# DESIGN DRAWINGS

*Oregon Square*

*Updated: September 14, 2015*

# COMMENTS TO ADDRESS - POST DR I

ENTRY GATES : LIGHTS GATE (WEST)

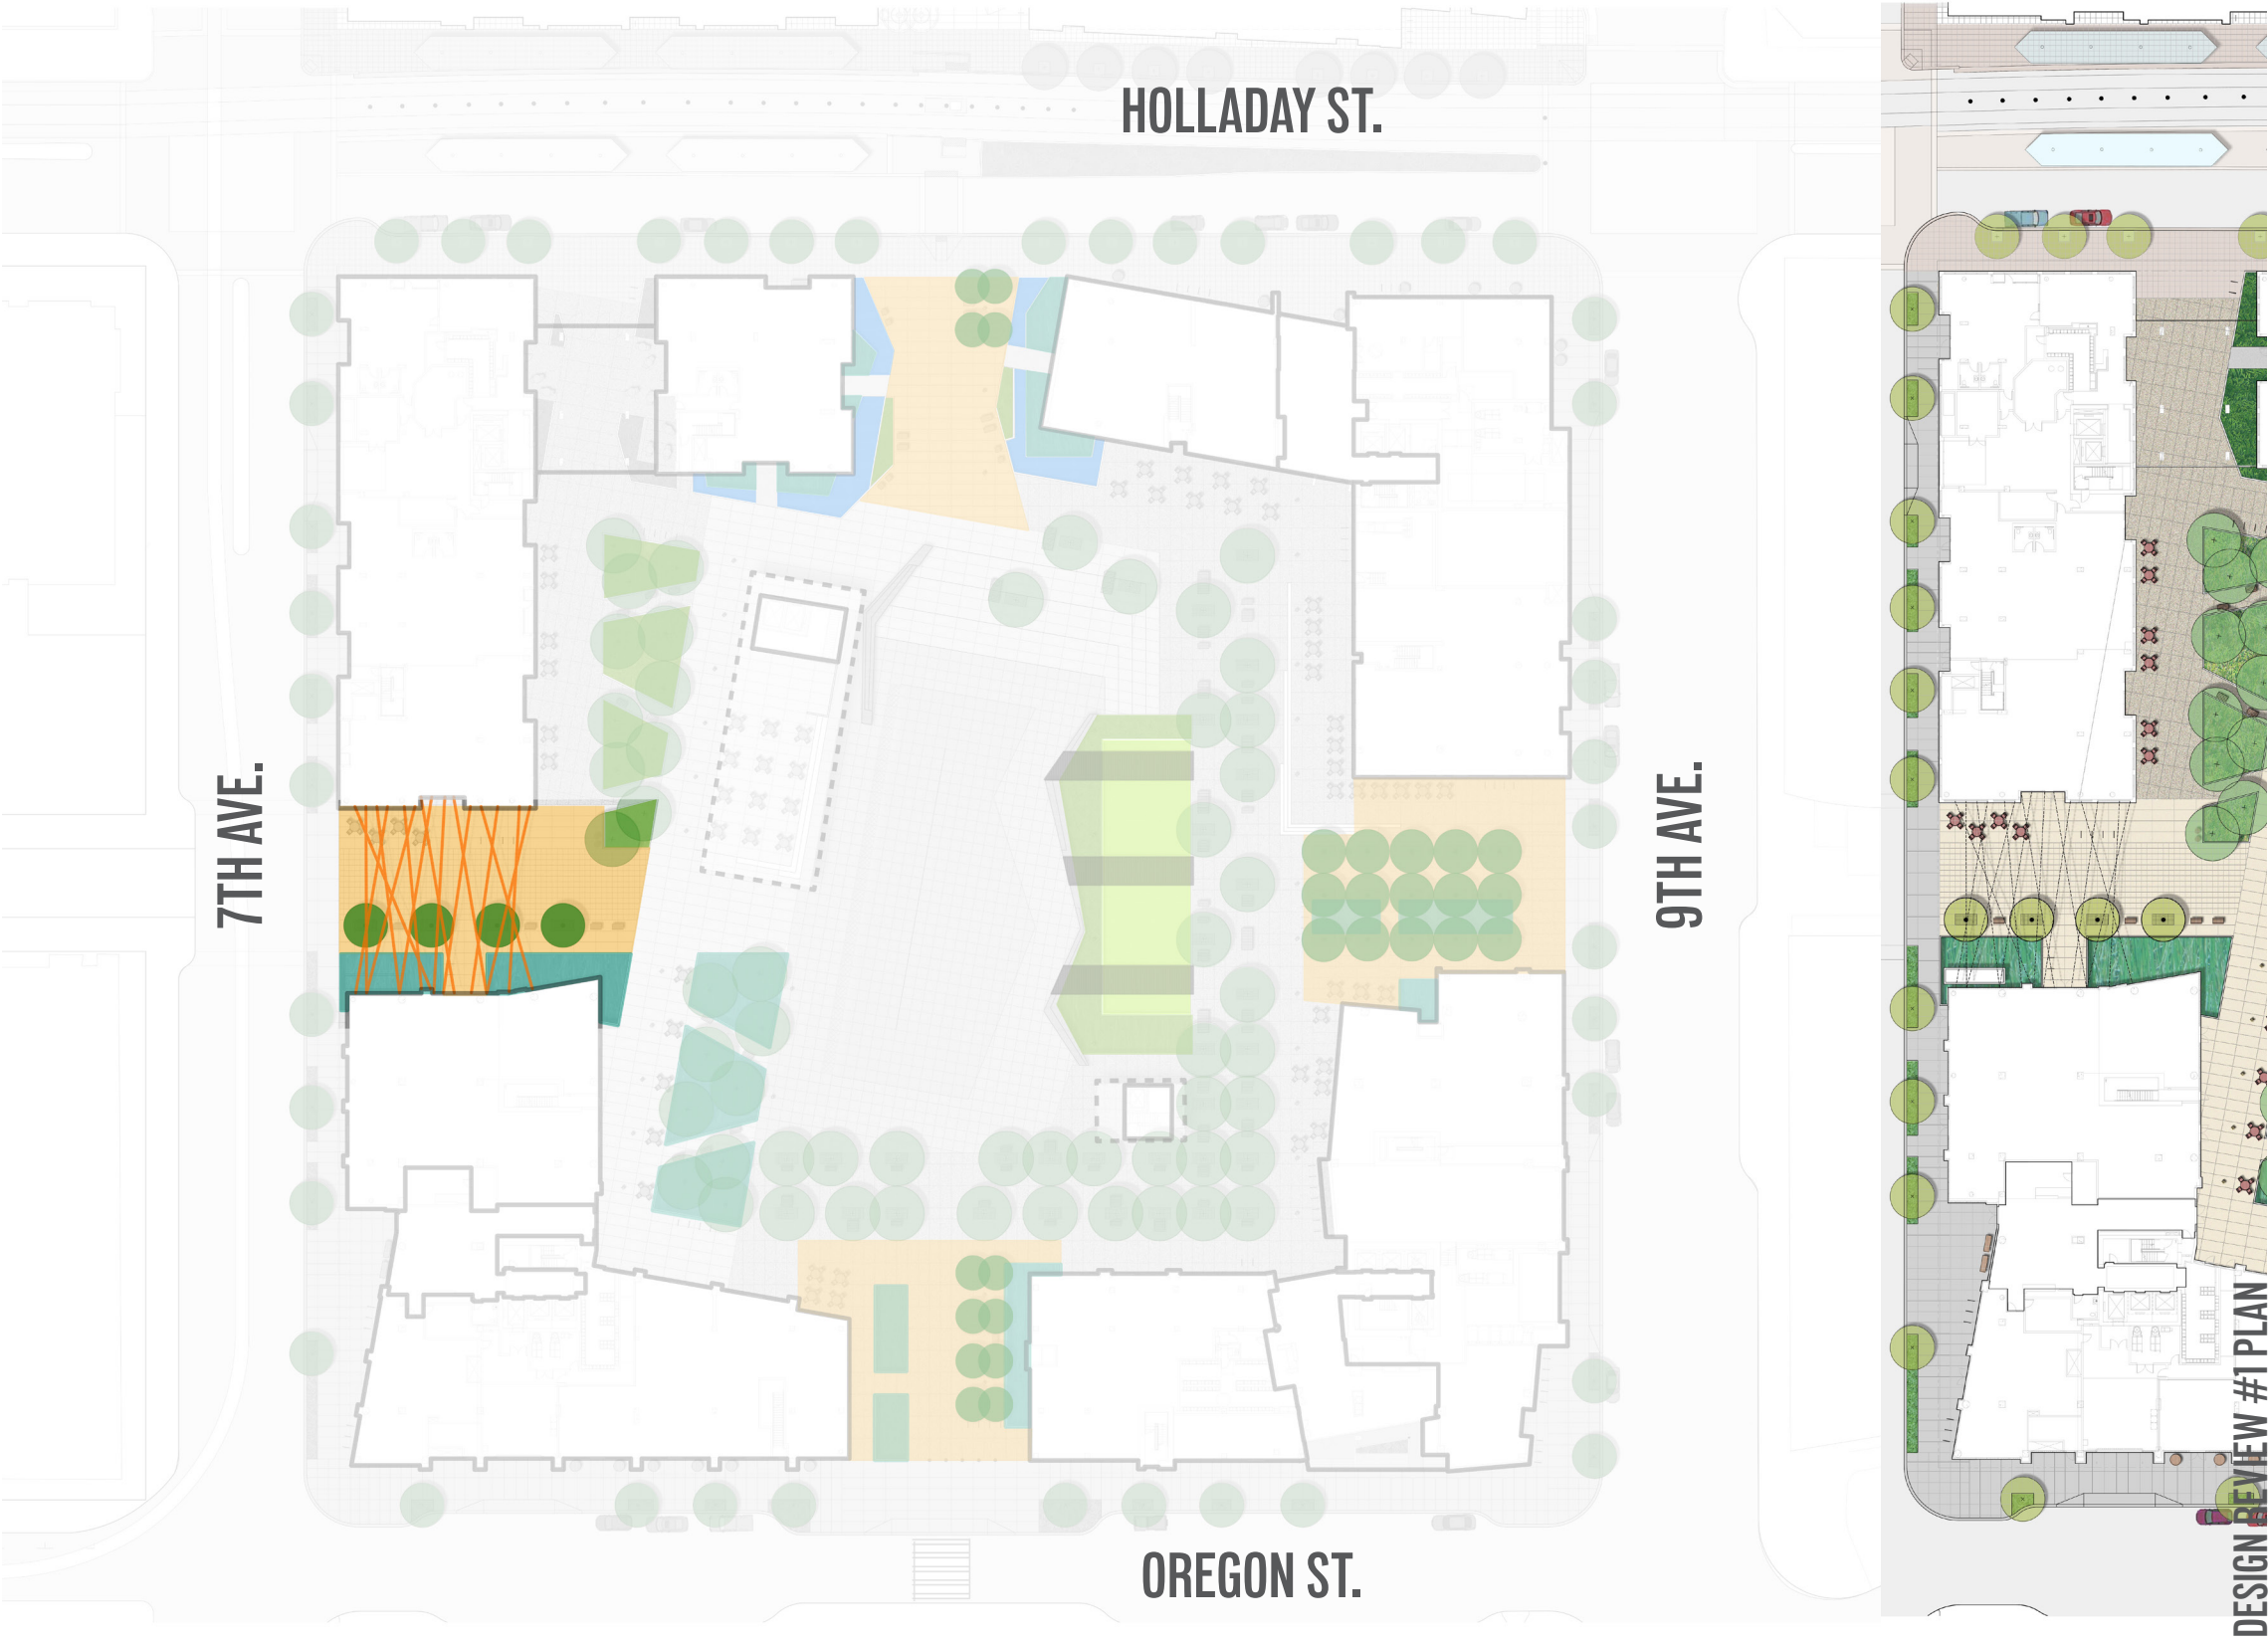
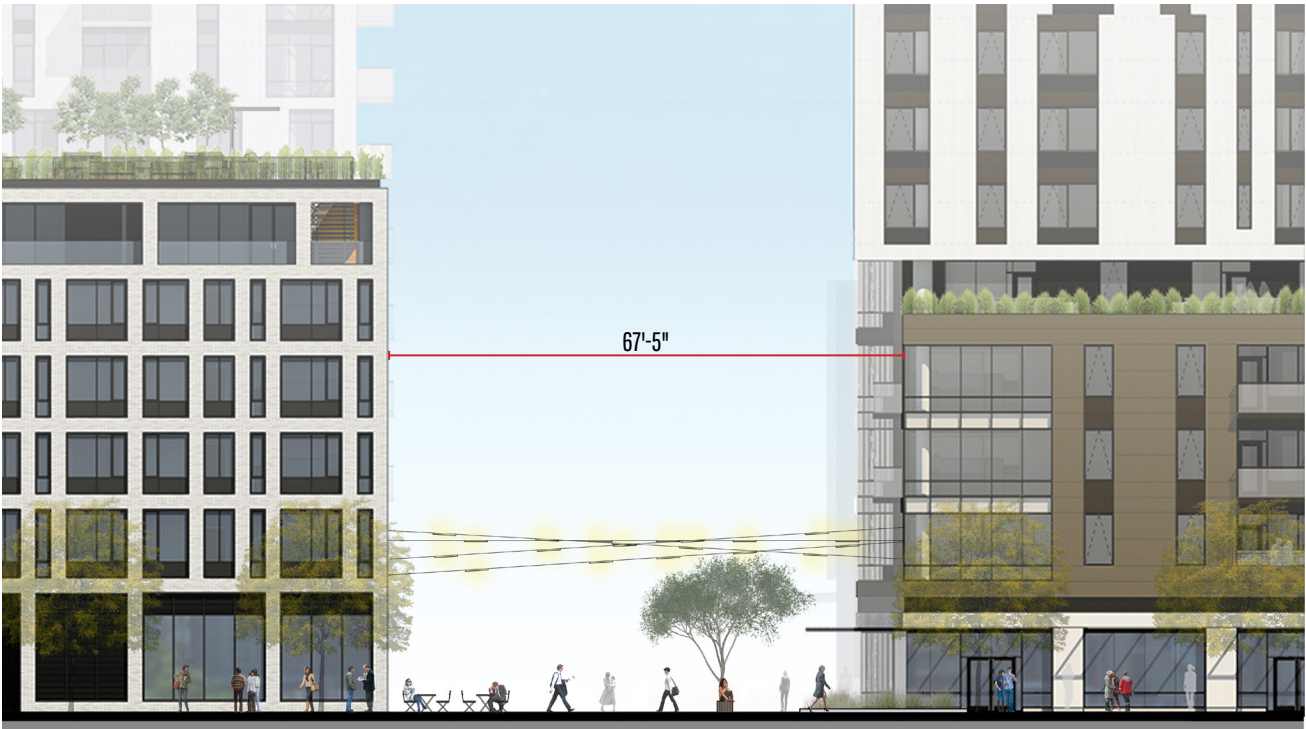
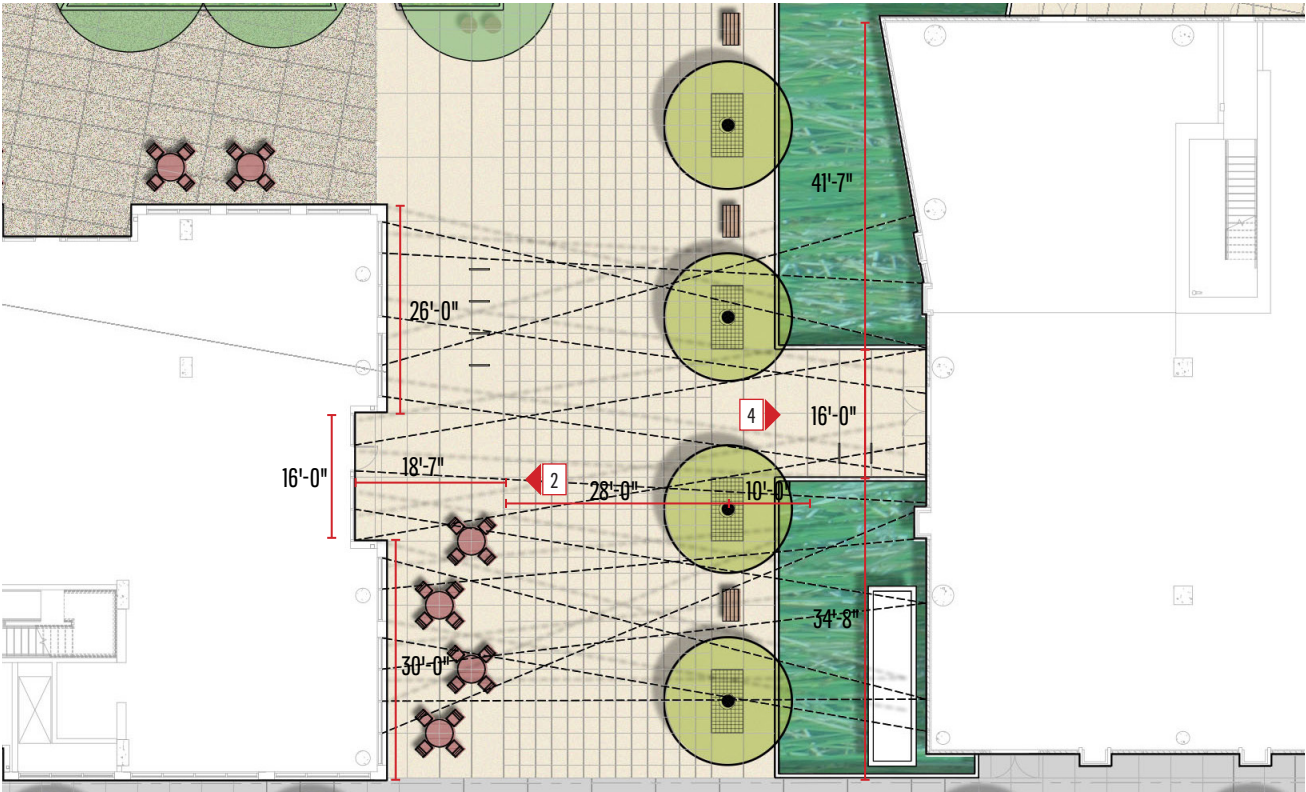
*Critical that building corners/portal edges are active and visible from streets*

THE LIGHTS GATE RETAINS A SENSE OF AMPLITUDE TO ACKNOWLEDGE THE CONNECTION OF THE SQUARE WEST TOWARDS THE CONVENTION CENTER.

BY REMOVING THE STORM WATER PLANTER ON THE NORTH SIDE OF THE GATE, THE EDGES AND CORNERS OF THE BUILDING MAINTAIN A BETTER CONNECTION TO THE PEDESTRIAN SPACE AND FLOW OF VISITORS.

THE EMPHASIS ON THE OVERHEAD LIGHTS WILL CREATE A FESTIVE SENSE OF ANNOUNCEMENT AND ARRIVAL TO THE SQUARE.

MODIFICATION #1

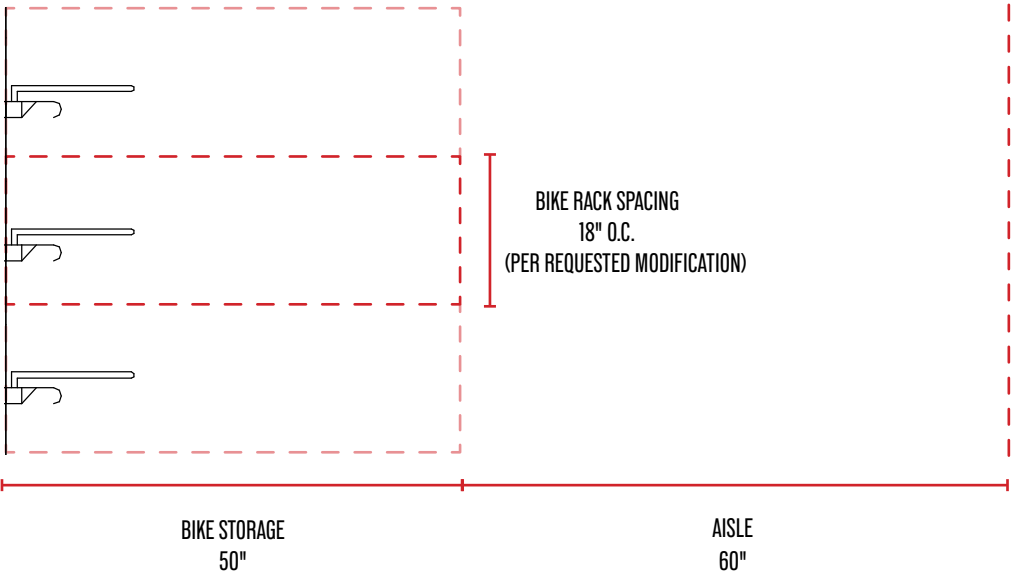
33.266.220.C.3.b.

General Standard: A space 2 feet by 6 feet must be provided for each required bicycle parking space.

We are proposing to use either a stacking rack with an assisted lift for the upper rack (Urban Racks articulating racks) or a vertical rack system with staggered rack heights (Urban Racks high density vertical racks), or a combination of both; both rack models are listed under the City of Portland Bike Parking Guide as pre-approved models that provide 2 points of contact with the bike when and frame, allow use of a U-lock through the rack, the wheel, and the frame, and may be used by bikes with mounted fenders without damaging fenders. We are providing 60” access aisle width for the vertical racks and a manufacturer recommended 84” aisle width for the stacking racks. Both kinds of racks will be anchored to the structural slabs in the garage in a centrally located shared bicycle hub. The City of Portland Bicycle rack handbook indicates that these racks must be used with a 24” per bike spacing, but the manufacturer suggests that 18” spacing is adequate. We request a modification to allow the vertical storage racks to be staggered on the wall at an 18” OC spacing, and the 60” aisle will start 48” from the wall – an 18” x 48” footprint per vertical rack. We believe this spacing has been approved elsewhere by the City of Portland, and even at 18” there is adequate room for access to locks. These racks are proposed to be used for long-term storage in a central controlled-access bike storage hub intended for use by residents and tenants of the Oregon Square project, and the bike storage room will be monitored by security. Because these racks will be used by residents and tenants, it can be assumed that they will have some familiarity with the rack systems and therefore the more generous 24” spacing required by the City of Portland guidelines is not required, and the manufacturer recommended 18” spacing is sufficient. We intend to maintain the 24” x 72” required footprint for short term bike parking available to the public, and if we use the stacking racks anywhere in the project, we will maintain the 24” spacing per bike, understanding that the 18” spacing, while approved by the manufacturer, does not provide adequate clearance for securing a bike lock
